# HUB U-DISTRICT | BROOKLYN

SDCI # 3032065-EG / #3032149-EG

Recommendation Meeting | SM-U 95-320 (M1)

April 15, 2019

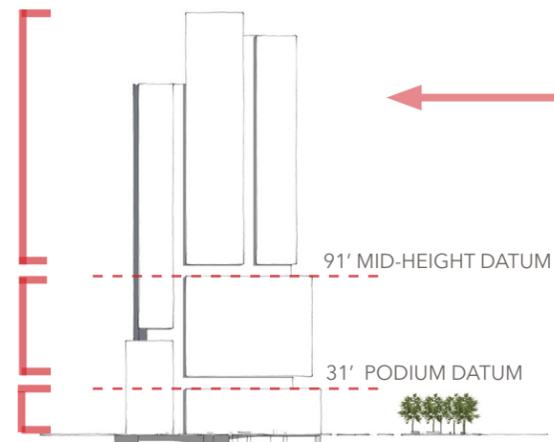
1a. The Board appreciated massing and design development since EDG1, specifically the studies related to integration of the base into the overall tower language, as well as gasket studies. (DC2-B-1. Façade Composition, University CS2-IV Height, Bulk, and Scale)

DEVELOPMENT SINCE EDG2  
 -Language of materiality correlates A, B, C pieces

EDG2: GASKET STUDY - BALANCED  
 -Proportion indicates hierarchy  
 -Gaskets articulate tower components  
 -Connect base, middle & top

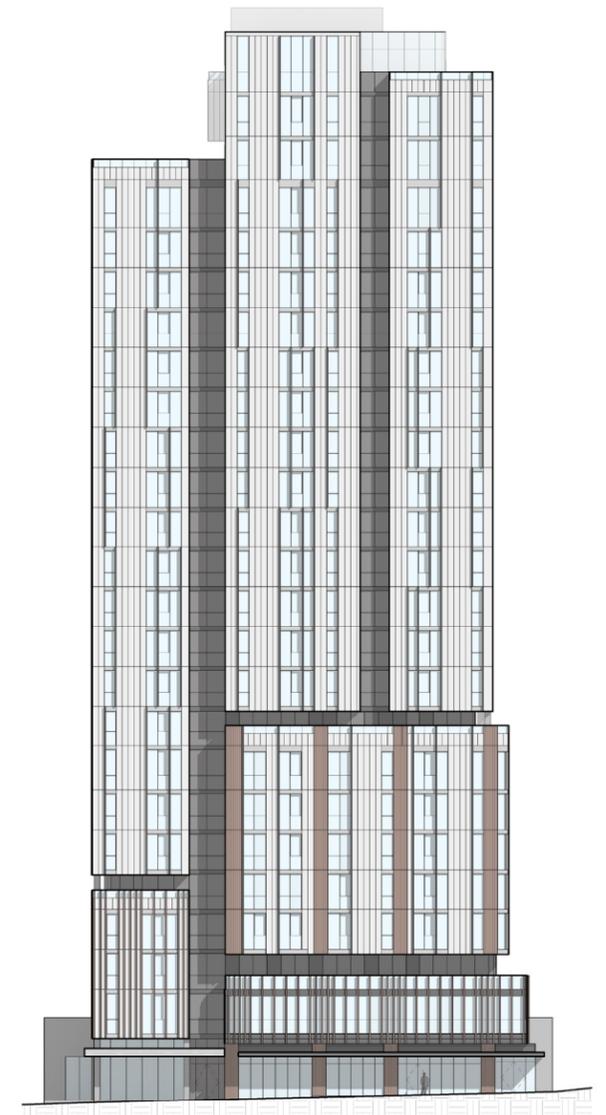
1c. The Board was highly supportive of refinements made to the gaskets which further broke down the tower scale by threading the gaskets throughout the tower form and creating a legible relationship with the neighborhood scale. (DC2-B-1. Façade Composition, University CS2-IV Height, Bulk, and Scale)

DEVELOPMENT SINCE EDG2  
 -Massing maintains proportion and hierarchy  
 -Materiality and tone of gaskets articulate tower massing  
 -Consistent elements in facade language at base, middle & top

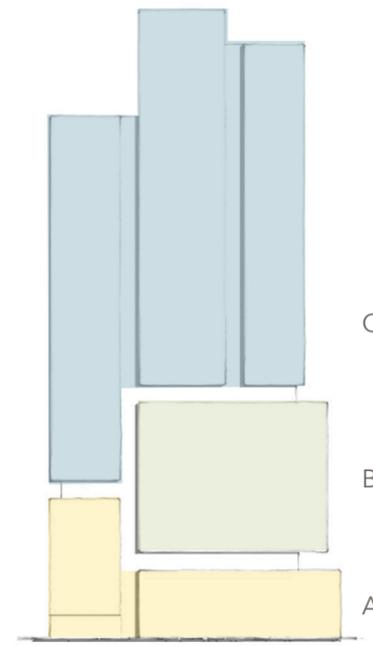
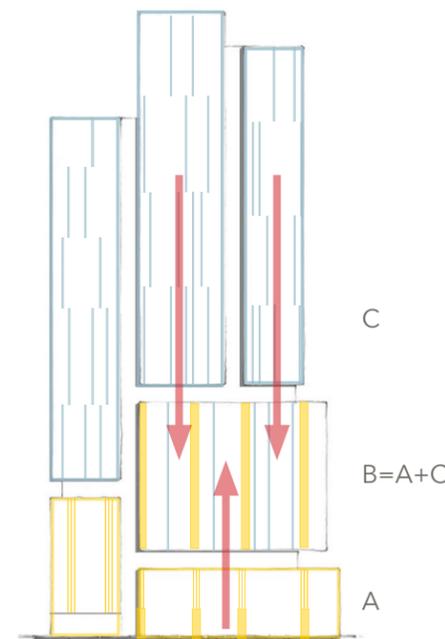
1d. Though the Board was highly supportive of the overall massing development, they were concerned articulation of volume B (as indicated on page 26 and page 36) was not yet resolved and seemed foreign to the rest of the tower language. The Board expanded on this item, noting the strong frame round volume B seemed to interrupt the verticality and regularity of the tower proportions, and appeared to introduce a new architectural language into the tower composition. In order to further the cohesion of volume B with tower components A and C (page 27) the Board directed the design team to (DC2-B-1. Façade Composition, DC2-D Scale and Texture):

- i. Simplify the proportions and material application to better transition from the base and upper stories.
- ii. Consider how the tectonic language and filtering fin language can further inform the refinements to volume B.
- iii. Consider how to refine volume B to support a more fluid transition from base (components A) to tower (components C).

- i. The language of the B volume has adopted the similar materiality to the A and C volumes to simplify the palette and provide continuity between all 3 volumes.
- ii. The horizontal elements of the B volume have been removed to suggest the vertical continuity of the fins between each of the 3 volumes. The subtraction of the horizontal elements emphasizes the gaskets as breaks between the volumes, reinforcing the tectonic nature of the facade.
- iii. With simplified language connecting the 3 volumes, the use of similar but not identical materials across the 3 volumes provides transitions between the volumes. The similar but not identical materials organizes the hierarchy of the volumes according to the pedestrian scale.

- Volume C = Tower | Dark Gray Metal Fins | Dissipation | City scale
- Volume B = Mid | Fins + Warm GFRC Panels | Distinct | Urban scale
- Volume A = Base | Warm Tone GFRC Panels/Fins | Tactile Warmth | Pedestrian scale

DEVELOPMENT:  
facade type B becomes a refined combination of types A and C

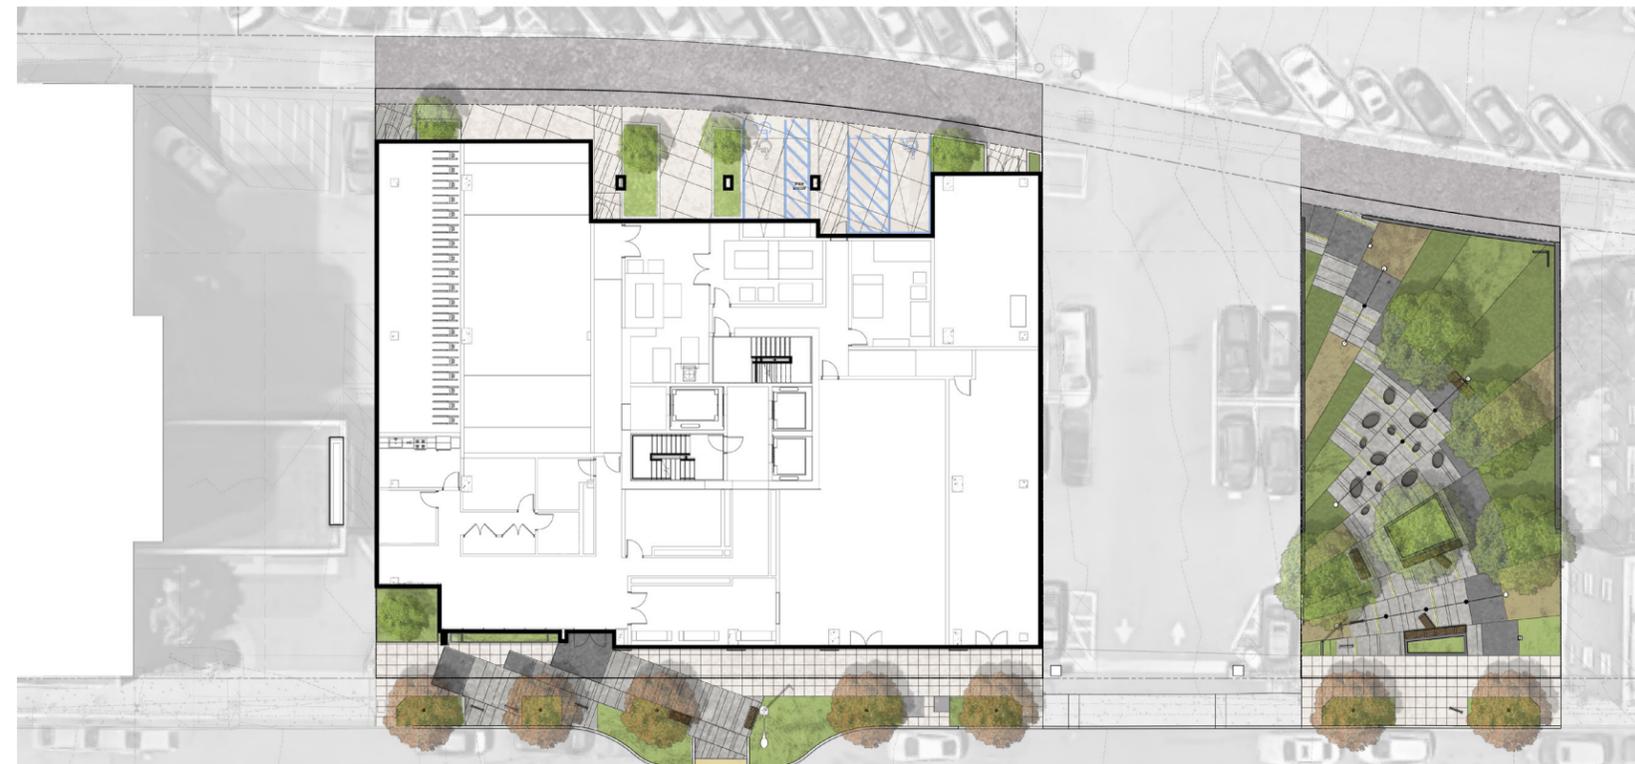
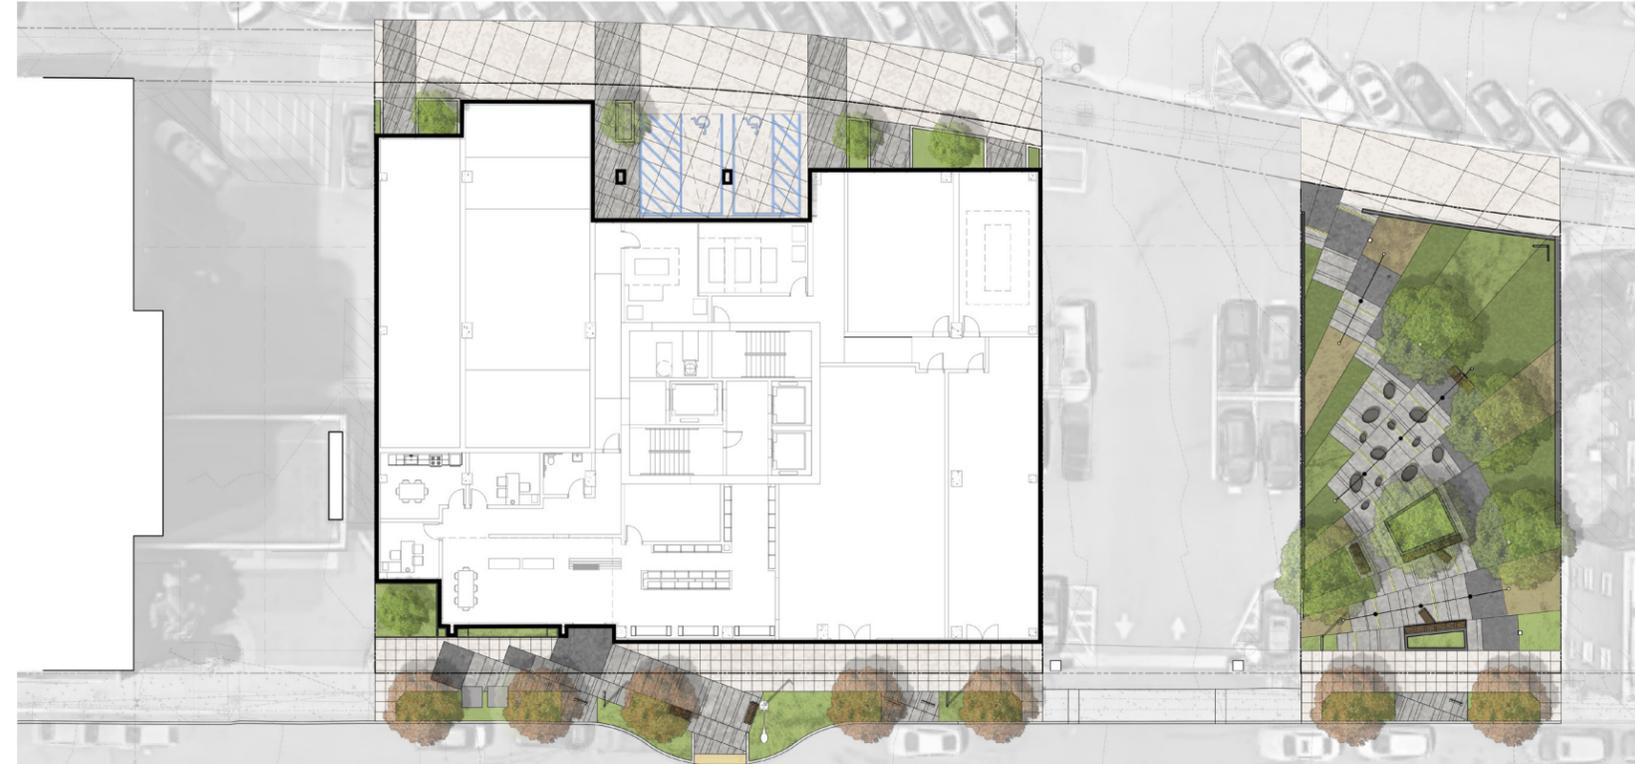
3a. The Board appreciated the development and increased clarity related to the neighborhood open space programming, circulation, and topography response. (DC3-B Open Space Uses and Activities)

3b. The Board supported the breakdown of the open space into a series of smaller moves. They noted the design successfully created a variety of zones throughout the space while balancing programming with future flexibility. (DC3-B Open Space Uses and Activities)

3c. The Board supported the integrated lighting, pebble seating, and proposed mural. (DC4-C Lighting, DC3-B Open Space Uses and Activities)

3d. The Board was also appreciative of increased arc of the through-pathway which improved connectivity through the site (DC3-B Open Space Uses and Activities)

3e. The Board supported raising the northwest corner of the open space to enhance sight lines, improve safety and security, and minimize dead space. (DC3-B Open Space Uses and Activities, PL2-B Safety and Security)
